FRONT ELEVATION (W)
SCALE 1:100

Date	Suffix	Description	Date	Suffix	Description	01-12-2023	A	PLANNING REVISION BRICK WORK ADDED TO FRONT/ GARAGE ELEVATION				05-01-2024	B	PLANNING REVISION: MAIN ROOF PITCH REDUCED, GARAGE PROJECTION REDUCED & PITCHED ROOF ADDED TO GARAGE				22-01-24	D	CABLE REINSTATED TO PLANNERS REQ & EAVES PROJECTIONS REDUCED.				05-02-2024	E	300MM DROP ADDED TO ROOF & REAR ELEVATION WALL REPOSITIONED, PLANNERS REQ.				<p>NYP ARCHITECTURAL SERVICES LIMITED <small>88C, Innovation Way, Barnsley, S75 1JL. Tel: 01226 200893. E-mail: scott@nypas.co.uk / stephen@nypas.co.uk</small></p>		
				Date	Suffix	Description	Date	Suffix	Description																														
01-12-2023	A	PLANNING REVISION BRICK WORK ADDED TO FRONT/ GARAGE ELEVATION																																					
05-01-2024	B	PLANNING REVISION: MAIN ROOF PITCH REDUCED, GARAGE PROJECTION REDUCED & PITCHED ROOF ADDED TO GARAGE																																					
22-01-24	D	CABLE REINSTATED TO PLANNERS REQ & EAVES PROJECTIONS REDUCED.																																					
05-02-2024	E	300MM DROP ADDED TO ROOF & REAR ELEVATION WALL REPOSITIONED, PLANNERS REQ.																																					
<p>Project:

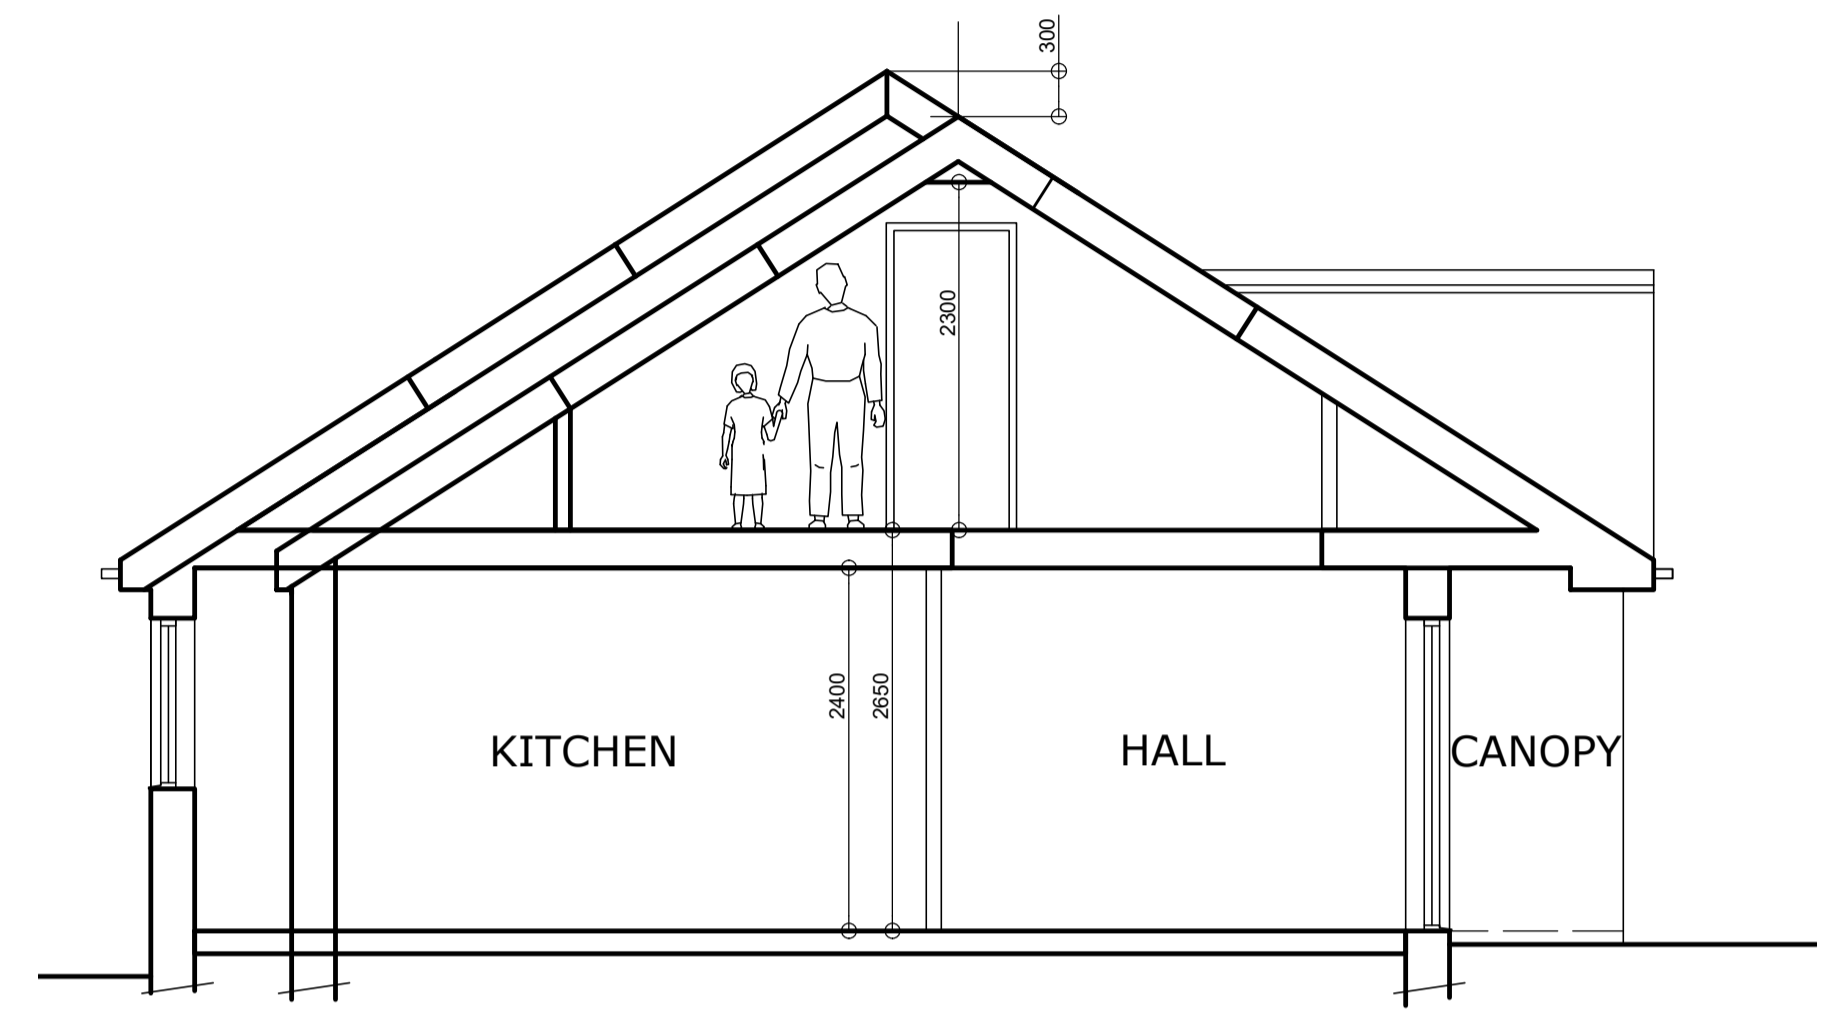
<table><tr> <th>Date</th> <th>Suffix</th> <th>Description</th> <th>Date</th> <th>Suffix</th> <th>Description</th> </tr><tr> <td>01-12-2023</td> <td>A</td> <td>PLANNING REVISION BRICK WORK ADDED TO FRONT/ GARAGE ELEVATION</td> <td></td> <td></td> <td></td> </tr><tr> <td>05-01-2024</td> <td>B</td> <td>PLANNING REVISION: MAIN ROOF PITCH REDUCED, GARAGE PROJECTION REDUCED & PITCHED ROOF ADDED TO GARAGE</td> <td></td> <td></td> <td></td> </tr><tr> <td>22-01-24</td> <td>D</td> <td>CABLE REINSTATED TO PLANNERS REQ & EAVES PROJECTIONS REDUCED.</td> <td></td> <td></td> <td></td> </tr><tr> <td>05-02-2024</td> <td>E</td> <td>300MM DROP ADDED TO ROOF & REAR ELEVATION WALL REPOSITIONED, PLANNERS REQ.</td> <td></td> <td></td> <td></td> </tr></table>
